Subject: Oconee Nuclear Station, Units 1, 2, and 3  
Docket Nos. 50-269, 270, and 287  
TAC Nos. MA3765, MA3766, and MA3767  
Response to Request for Additional Information  
Related to Reactor Building Overpressure for  
Reactor Building Spray Pumps Net Positive Suction  
Head.

ATTACHMENT 1

CHART 1

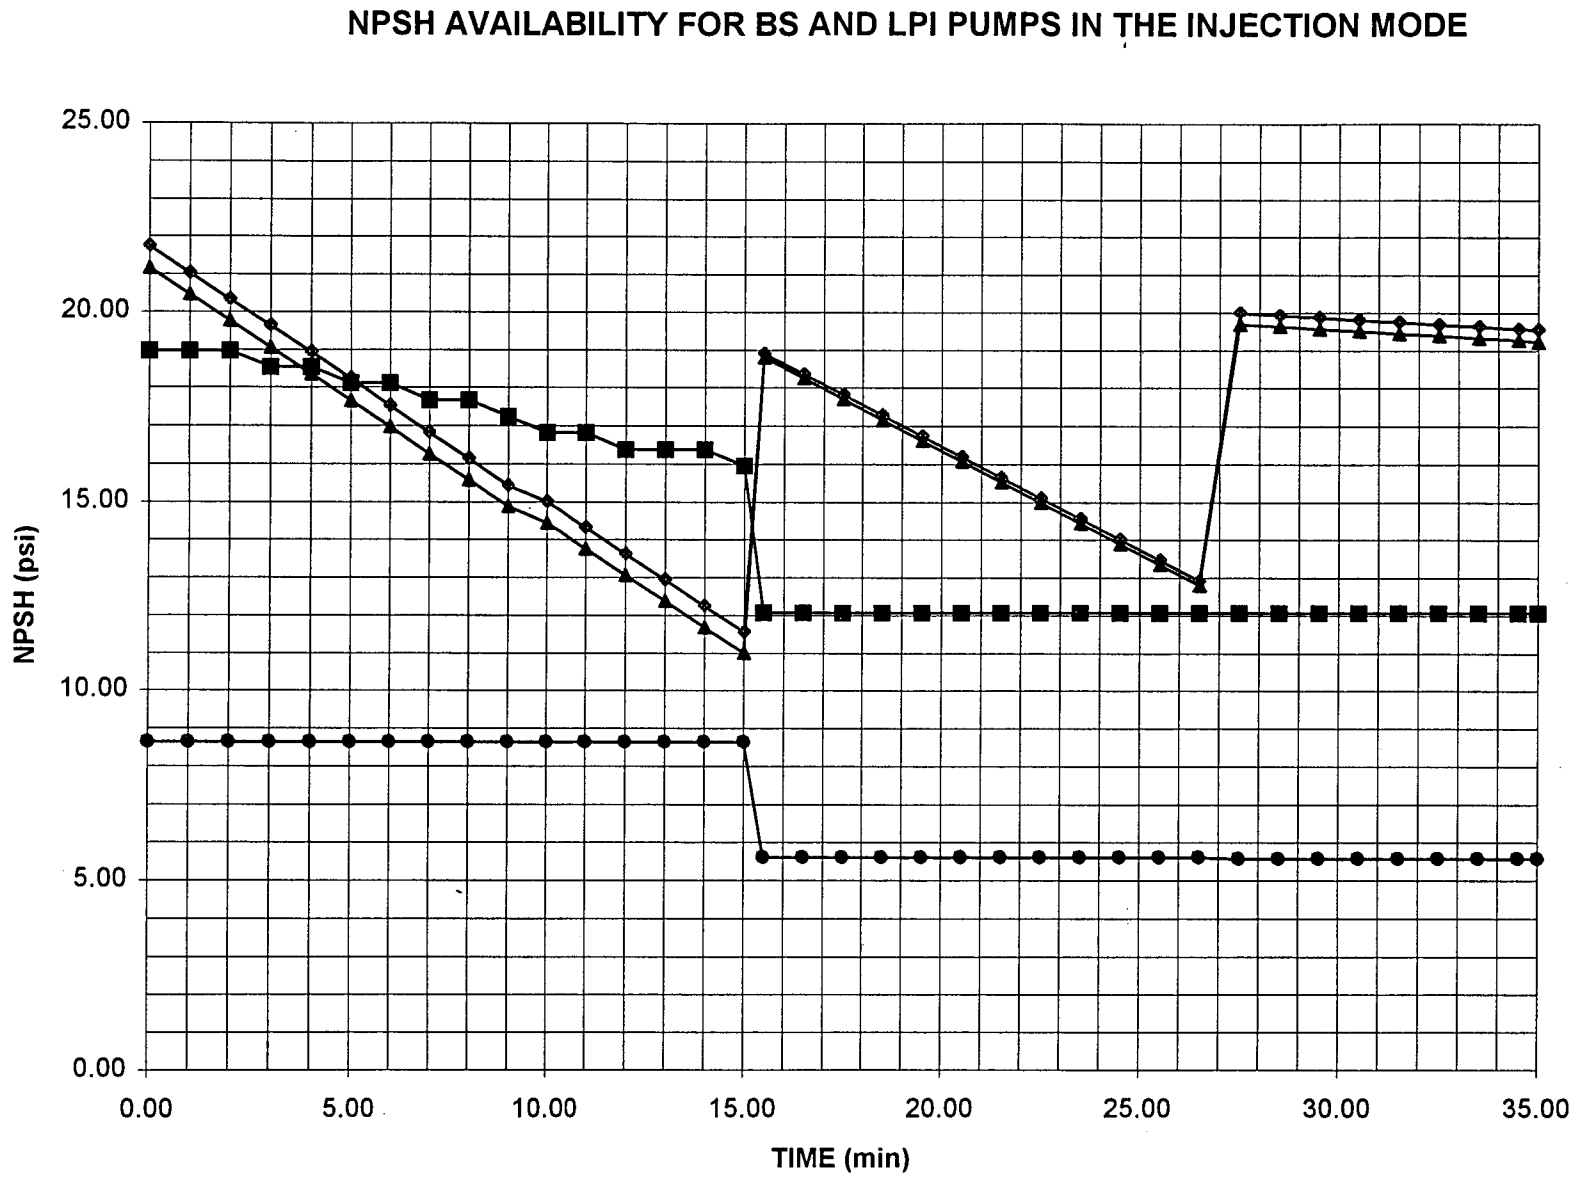
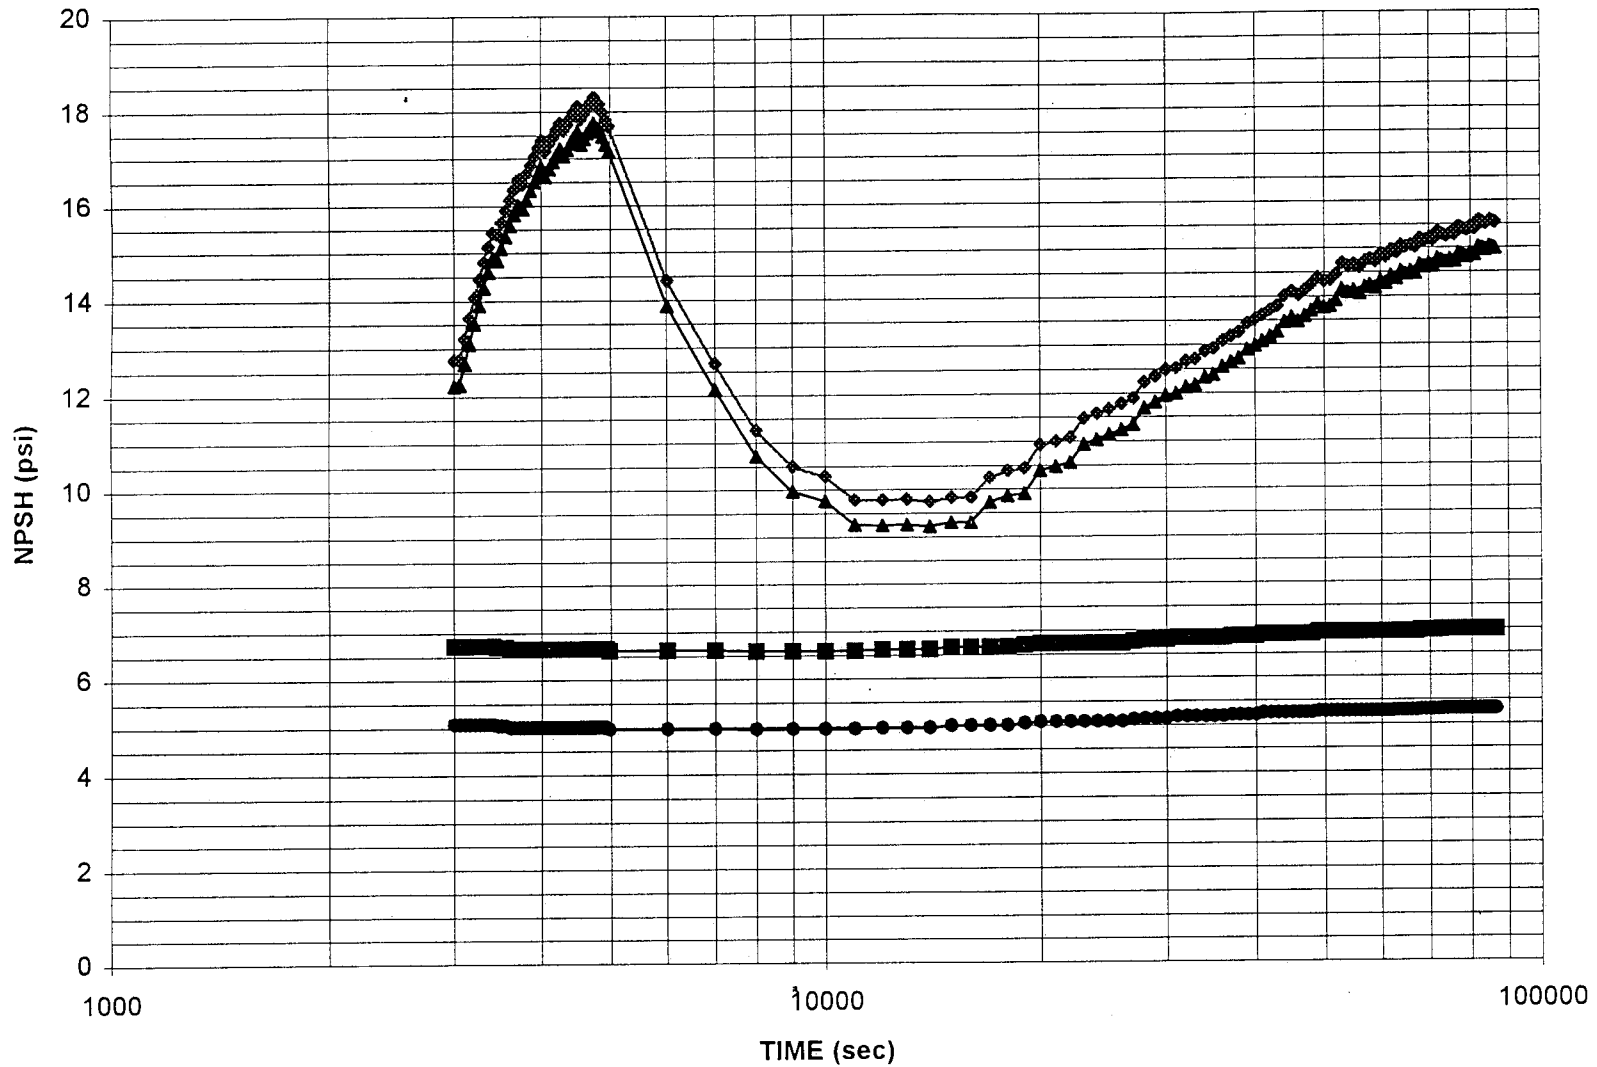
Provide a graph that depicts the NPSH required in pounds per square inch for the RBS and LPI pumps versus time and the calculated NPSH available versus time. A sample of the type of graph that is requested is provided for your convenience.

The following graphs depict the NPSH required (NPSH<sub>r</sub>) and NPSH available (NPSH<sub>a</sub>) for the RBS and LPI pumps for both the injection and recirculation phases. There are three graphs for the recirculation mode (Charts 2A, 2B, and 2C), each shows NPSH assuming a different Reactor Building Cooling Unit (RBCU) cooling capacity. The NPSH available curves shown on the graphs for the recirculation mode include containment overpressure.

### EXPLANATION OF DATA ON CHART 1

There are three distinct regions shown on Chart 1 for the injection phase. These are discussed individually below:

1. The first region is from 0 to 15 minutes following the onset of the LOCA. The 'C' High Pressure Injection (HPI) pump is assumed to be throttled to approximately 500 gpm at 10 minutes into the event. No other pump throttling is assumed during this time period. Simulator testing has demonstrated that all ECCS and Building Spray pumps will be throttled within this 15 minute window. However, for analytical purposes, The Low Pressure Injection (LPI) pumps and Building Spray pumps are assumed to be throttled at 15 minutes for conservatism.

The available NPSH decreases below the required NPSH for the Building Spray (BS) pumps at approximately 5 minutes into the event. The available NPSH is approximately 4.5 psi below the required NPSH prior to throttling at 15 minutes into the event. This NPSH deficiency has been documented and evaluated under Duke's Problem Investigation Process (PIP) and reported to the NRC in Licensee Event Report (LER) 269/1998-12 submitted on November 2, 1998. The operability of the Building Spray pump under these conditions has been verified by test. Testing was performed on a pump of the same model and size as the Oconee Building Spray pumps at the pump manufacturer's facility on November 13, 1998.

2. The second region is represented by the period of time between 15 minutes and approximately 26.5 minutes. In this region, LPI pumps are throttled to 3000 gpm indicated flow, BS pumps are throttled to 1500 gpm indicated flow, and HPI pumps are assumed to operate throttled to 1500 gpm indicated flow. This region ends at a Borated Water Storage Tank (BWST) level of approximately 6 feet, when the transfer of pump suction source from BWST to Reactor Building Emergency Sump (RBES) is initiated. When throttling occurs at 15 minutes, the required BS NPSH is again satisfied, as the

NPSH requirements decrease and the available NPSH increases, both in a step change fashion. Available NPSH continues to decrease as the BWST is depleted.

3. The third region represents the time from the beginning of swapover (approximately 6 feet BWST level indicated) to the end of swapover (approximately 2 feet of BWST level indicated). When a BWST level of 6 feet (indicated level) is reached, HPI pumps are secured and sump isolation valves are opened. Flow from the BWST is substantially reduced when the HPI pumps are secured. There is an accompanying increase in available NPSH for the BS and LPI pumps due to the reduced friction losses at lower flow rates. Also, the opening of the sump isolation valves significantly reduces flow from the BWST, as flow begins to split between the sump and the BWST. This reduction in flow from the BWST also raises NPSHa due to the lower friction losses in the supply lines from the sump. At or before reaching a level of 2 feet (indicated) in the BWST, the BWST isolation valves are closed, and the injection phase of the event is terminated at approximately 35 minutes.
